| Directed Number | Item Name |
|-------------------|--|
| 1 620-10070-01(A) | PLASTIC 6711T IVU TOP HOUSING, HIGH-HEAT ABS + UV, DIPOLE |

SCALE: 1:1 UNITS: M/M DRN BY: SRZ DATE: 4/25/08
TITLE: NUTTEK CORPORATION

SIZE: A4 DEPT: MND LCD IVU DRAWING NO: 9610600-1 REV: 3

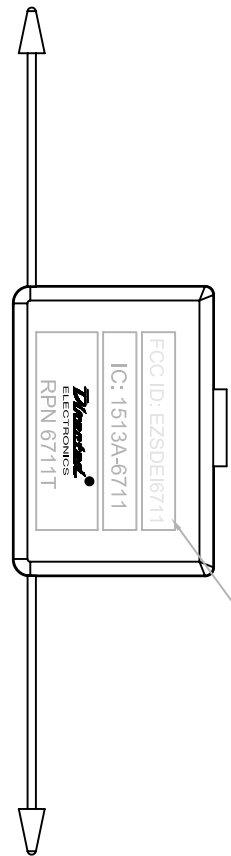
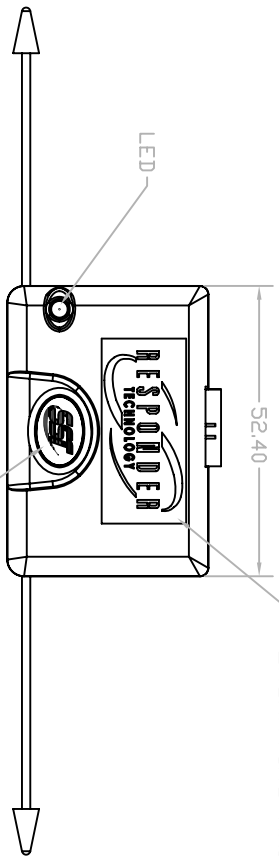
CHANGE CORE CAVE=0,3
ENGRAVING RAISED=0,25

CHANGE CORE CAVE=0
ENGRAVING RAISED=0,25

CHANGE CORE CAVE=0
ENGRAVING RAISED=0,25
